### **ADDENDUM No. 7** **Published March 5, 2021**

# ADDENDUM No. 7

## TO THE CITY OF FRESNO

### PUBLIC WORKS STANDARD DRAWINGS AND SPECIFICATIONS

P-4

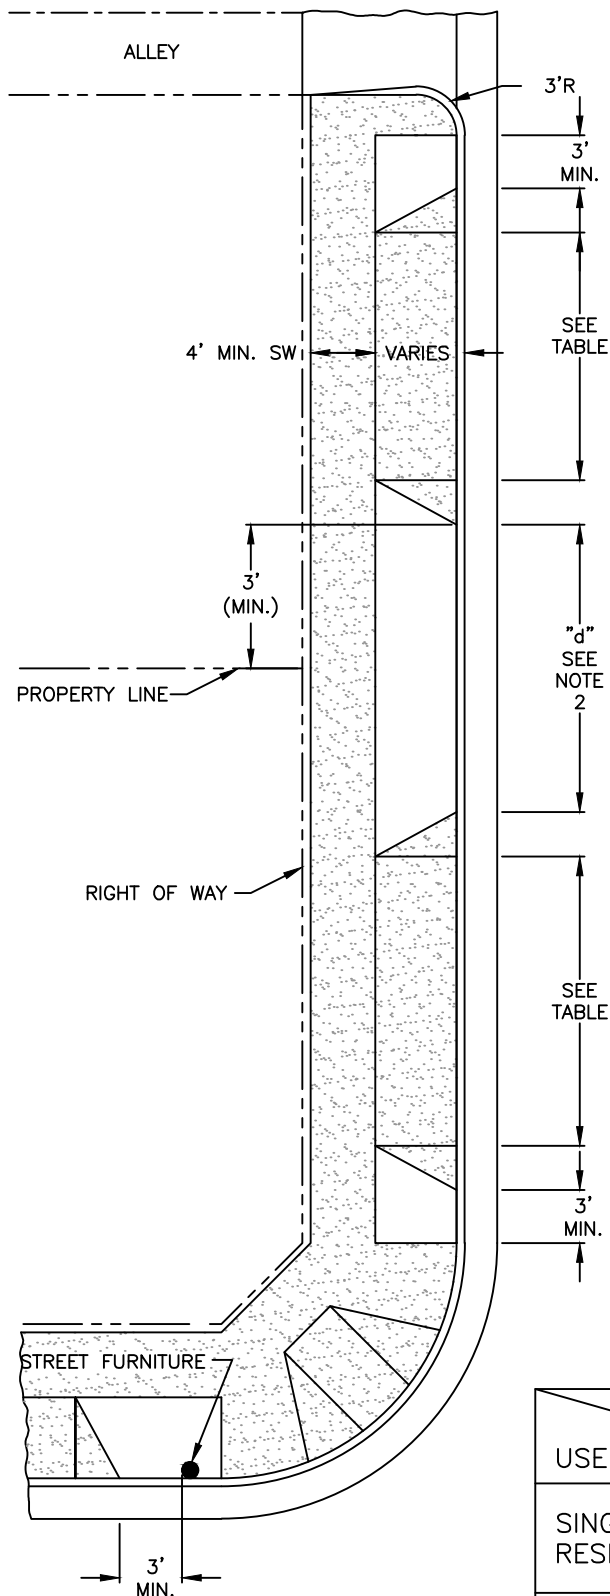
DPW – PUBLIC WORKS (P Series)	
<b>P-4</b>	<ol style="list-style-type: none"> <li>Multiple options for Dimension “B” removed; Dimension B now refers to Standard Drawing P-6 for driveway widths.</li> <li>Clarified “STREET FURNITURE” locations shown on diagram.</li> <li>Comments previously marked with a single asterisk “*” incorporated into new dimension “C”.</li> <li>Comments previously marked with two asterisks “**” converted to Note 1.</li> <li><b>Added Note 2:</b> “SEE API-7, API-8, AND API-9 FOR S. MINNEWAWA AVE. BETWEEN FANCHER CREEK AND CALIFORNIA AVE, BETWEEN CALIFORNIA AVE. AND BUTLER AVE., AND FROM BUTLER TO TULARE AVE.”</li> <li><b>Added Note 3:</b> “SEE API-6 FOR VAN NESS EXTENSION BETWEEN HERNDON AVE. AND SAN JOAQUIN RIVER BLUFF.”</li> <li><b>Added Note 4:</b> “SEE API-3, API-4 FOR DETAILS RELATING TO MODIFIED STREET TYPES.”</li> <li>Prior “REF. &amp; REV.” date erroneously shown as June 2015, date corrected to reflect its prior revision with the issuance of Addendum 5 in Oct. 2014.</li> </ol>

CITY OF FRESNO  
W-29

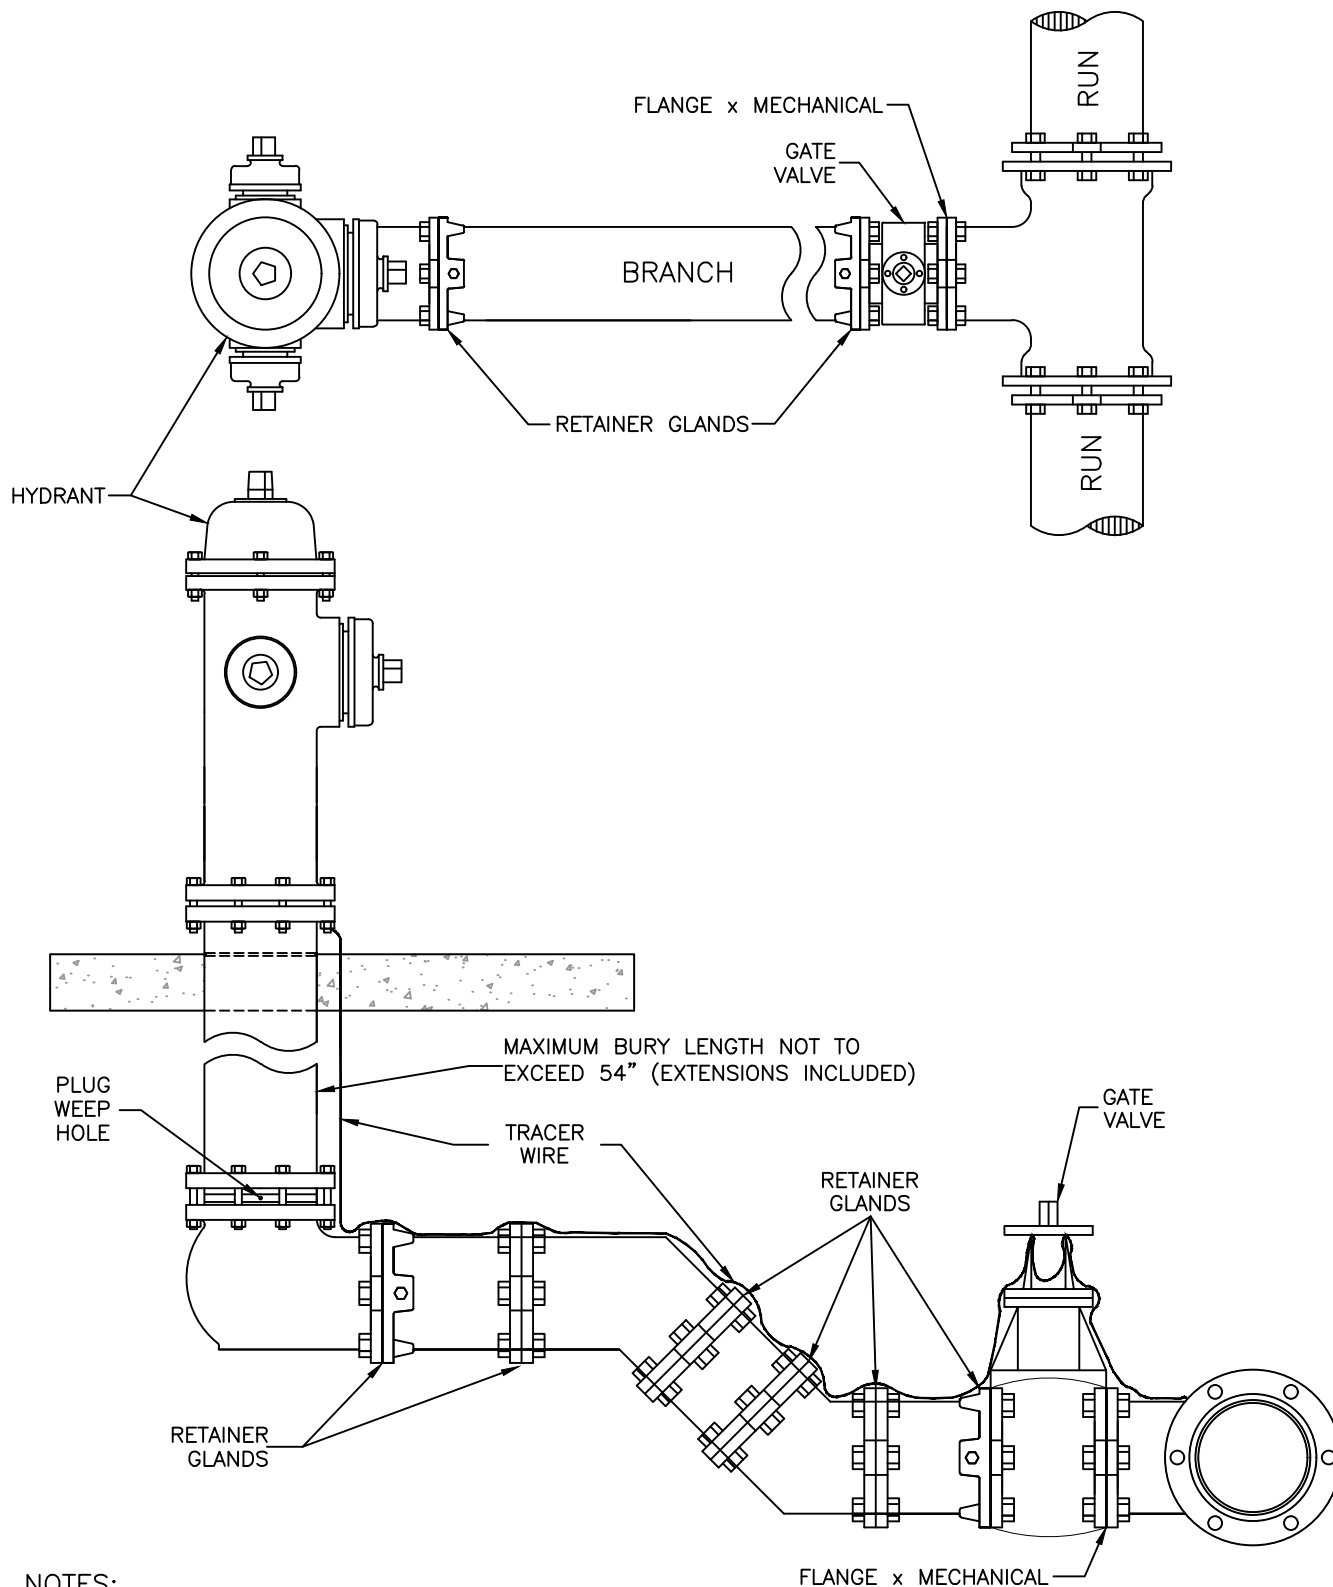
<b>W-29</b>	<p>1. <b>Drawing title:</b> "WATER MAIN BEDDING DETAILS" <b>Revised to read:</b> "WATER MAIN TRENCH, BEDDING, AND BACKFILL DETAIL"</p> <p>2. <b>Drawing has been revised in its entirety</b> to reflect current installation standards.</p>
<b>W-37</b>	<p>1. The following changes have been made to the drawing:</p> <ul style="list-style-type: none"> <li>a. <b>Plan view:</b> of Fire Hydrant <b>Revised</b> to reflect current Fire Hydrant style.</li> <li>b. <b>Moved:</b> "CONTROL VALVE" to Tee.</li> <li>c. <b>Changed:</b> "CONTROL VALVE" to "GATE VALVE"</li> <li>d. <b>Added:</b> "FLANGE X FLANGE" between Control Valve and Tee.</li> <li>e. <b>Changed:</b> "FLANGE X FLANGE" to "FLANGE X MECHANICAL"</li> <li>f. <b>Added:</b> Tracer Wire.</li> <li>g. <b>Added callout:</b> "PLUG WEEP HOLE"</li> <li>h. <b>Added depiction:</b> Retainer Glands shown throughout drawing to reflect full restraints.</li> <li>i. <b>Added callout:</b> "MAXIMUM BURY LENGTH NOT TO EXCEED 54" (EXTENSIONS INCLUDED)".</li> </ul>

CITY OF FRESNO  
W-43

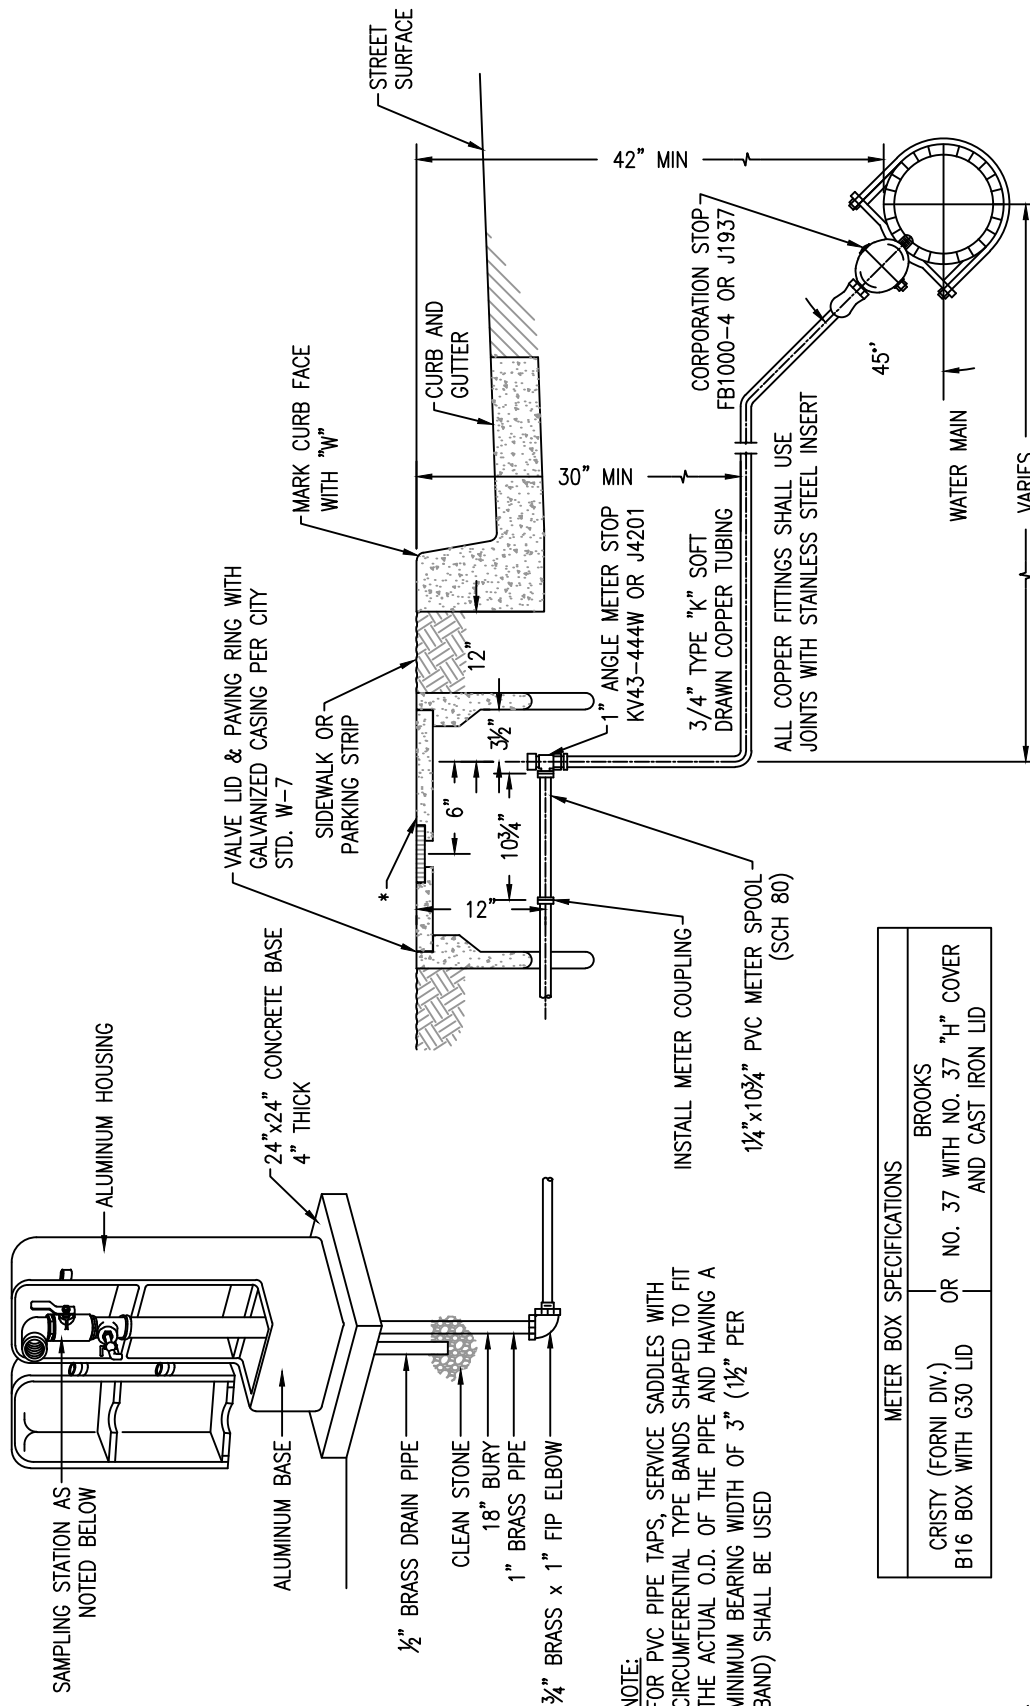
<b>W-43</b>	<p>1. <b>Modified detail</b> to reflect the use of flanged connections at the TEE's and risers.</p> <p>2. <b>Added callout:</b> "TO BE RETURNED TO CONTRACTOR AFTER WATER SYSTEM ACCEPTANCE AND FINAL WET-TIE BY CITY".</p> <p>3. <b>General Notes</b> bullet list <b>changed</b> to numbered. <i>No technical changes made to Notes.</i></p>
<b>W-44</b>	<p>1. <b>Revised</b> standard drawing <b>to reflect</b> an installation that complies with the requirements of standard drawing W-2.</p>

CITY OF FRESNO  
ITS-1

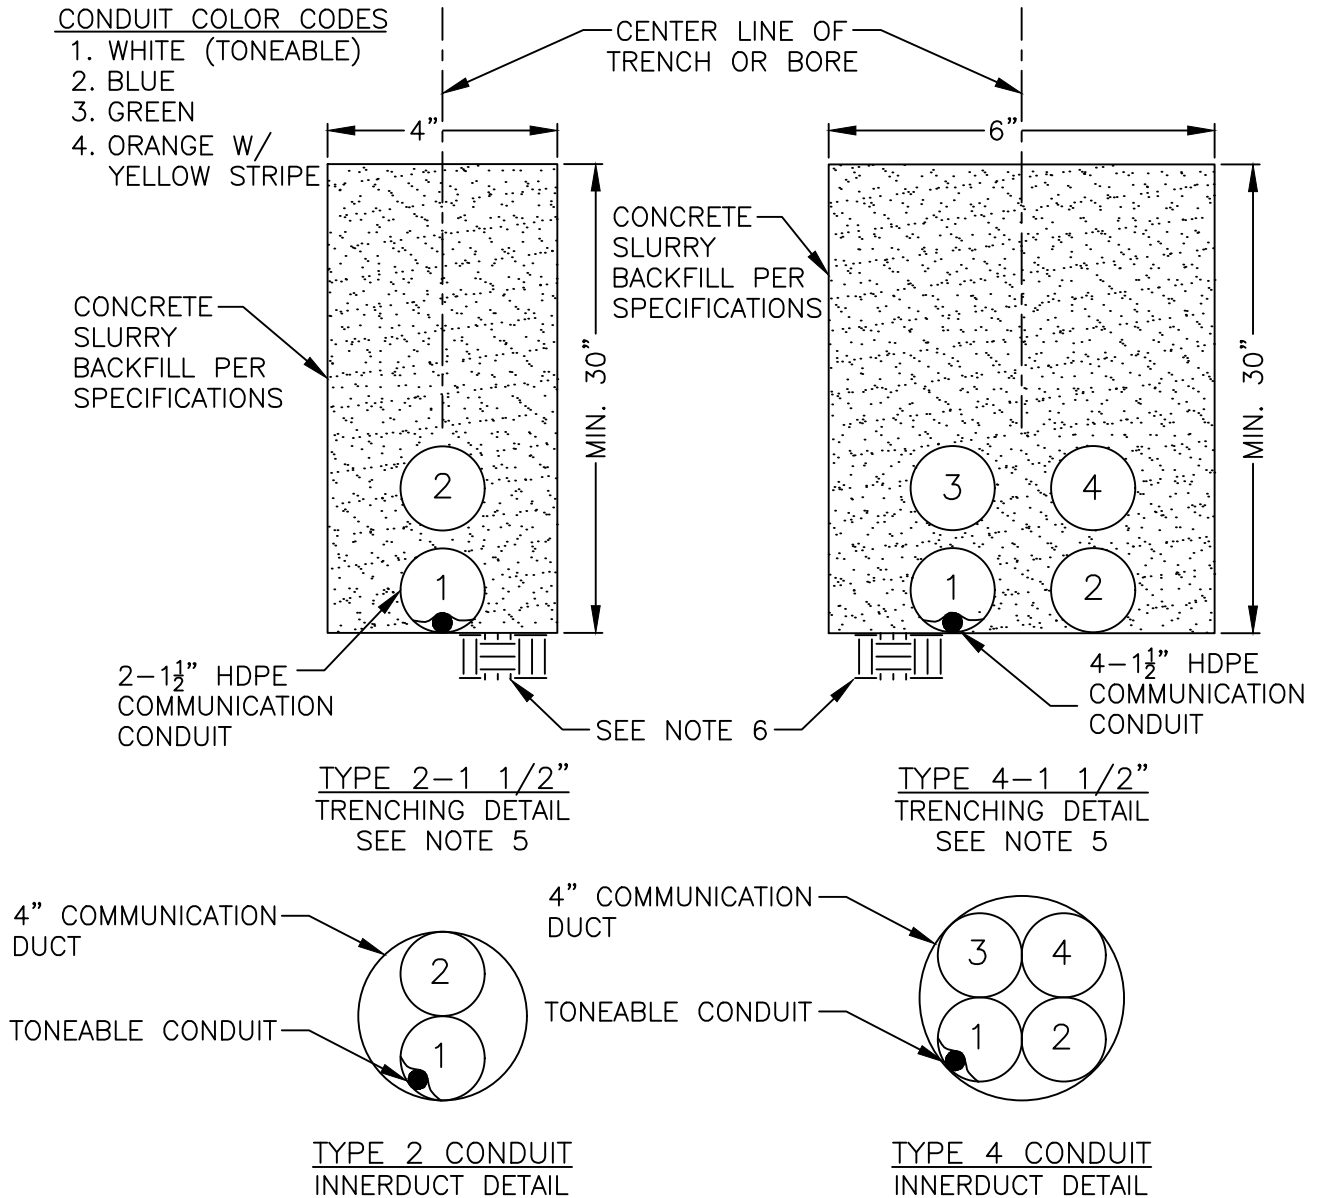
<b>ITS-3</b>	1. <b>Added callout:</b> “SEE NOTE 11” 2. <b>Added conduit and callout</b> for 1-1/2” RGC between Traffic Signal Service Cabinet and PG&E No. 2 Service box. 3. <b>Legend:</b> “ITS CONDUIT” <b>Revised to read:</b> “ITS CONDUIT, HDPE CONDUIT” 4. <b>Legend:</b> “TRAFFIC SIGNAL CONDUITS” <b>Revised to read:</b> “TRAFFIC SIGNAL CONDUITS, RIGID GALVANIZED CONDUIT (RGC)” 5. <b>Note 2:</b> “ITS INTERSECTION COMMUNICATION CABINET PER CURRENT CITY OF FRESNO QUALIFIED PRODUCT LIST. (QPL)” <b>Revised to read:</b> “ITS INTERSECTON COMMUNICATIONS CABINET, SEE STD PLAN ITS-20A”

CITY OF FRESNO  
ITS-20

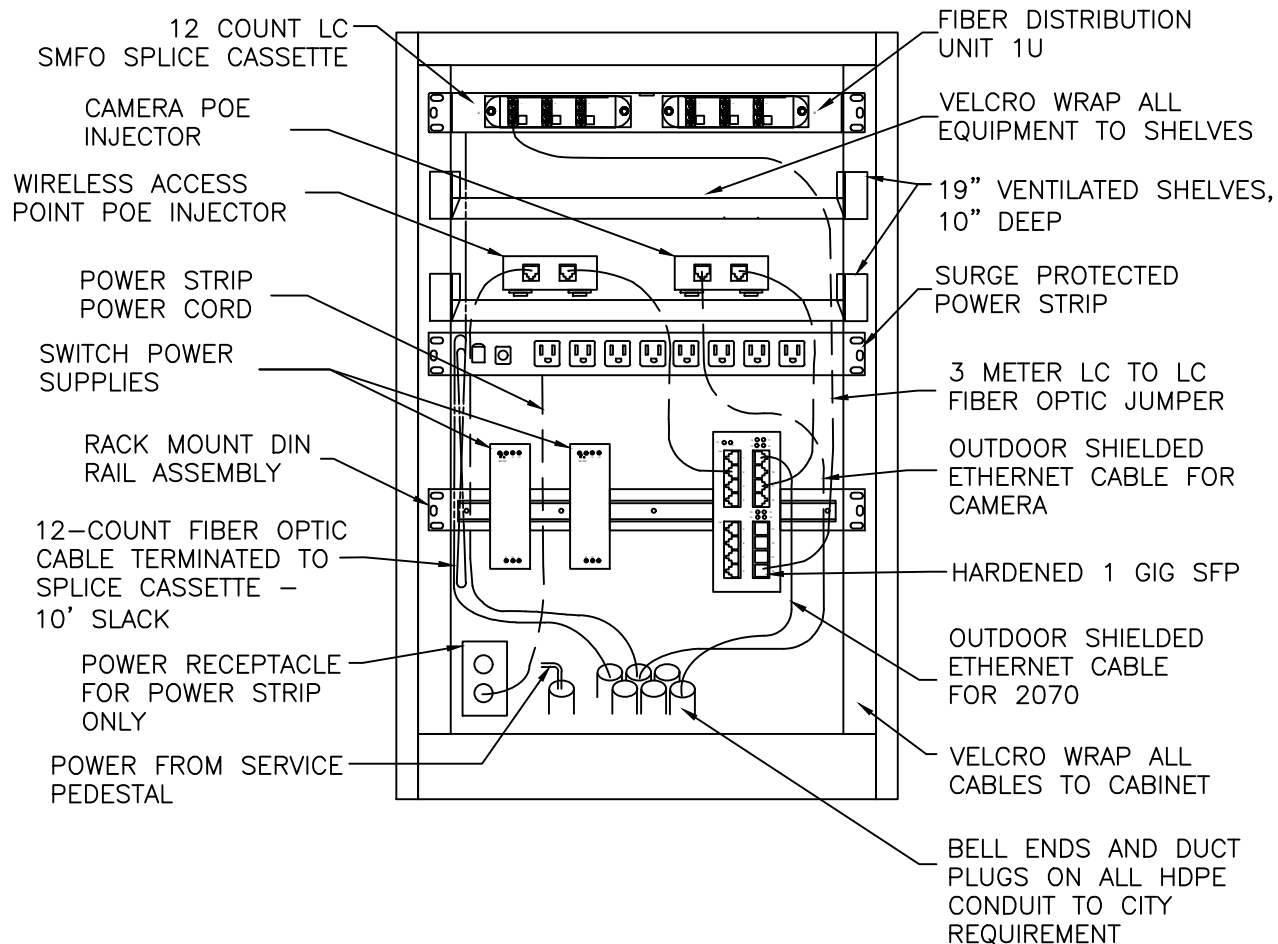
<b>ITS-20</b>	<ol style="list-style-type: none"> <li>1. Standard Drawing no longer used.</li> </ol>
<b>ITS-21</b>	<ol style="list-style-type: none"> <li>1. Standard Drawing no longer used.</li> </ol>
<b>ITS-21B</b>	<ol style="list-style-type: none"> <li>1. <b>Callout:</b> "12 COUNT SC PANEL" <b>Revised to read:</b> "12 COUNT LC SMFO SPLICE CASSETTE"</li> <li>2. <b>Added Callout:</b> "CAMERA POE INJECTOR"</li> <li>3. <b>Added Callout:</b> "WIRELESS ACCESS POINT POE INJECTOR"</li> <li>4. <b>Callout:</b> "IP POWER STRIP CORD" <b>Revised to read:</b> "POWER STRIP POWER CORD"</li> <li>5. <b>Drawing Revised</b> to include depiction of 2 DIN rail mounted switch power supplies</li> <li>6. <b>Removed callout:</b> "BACK OF IP POWER STRIP"</li> <li>7. <b>Added Callout:</b> "RACK MOUNT DIN RAIL ASSEMBLY"</li> </ol>
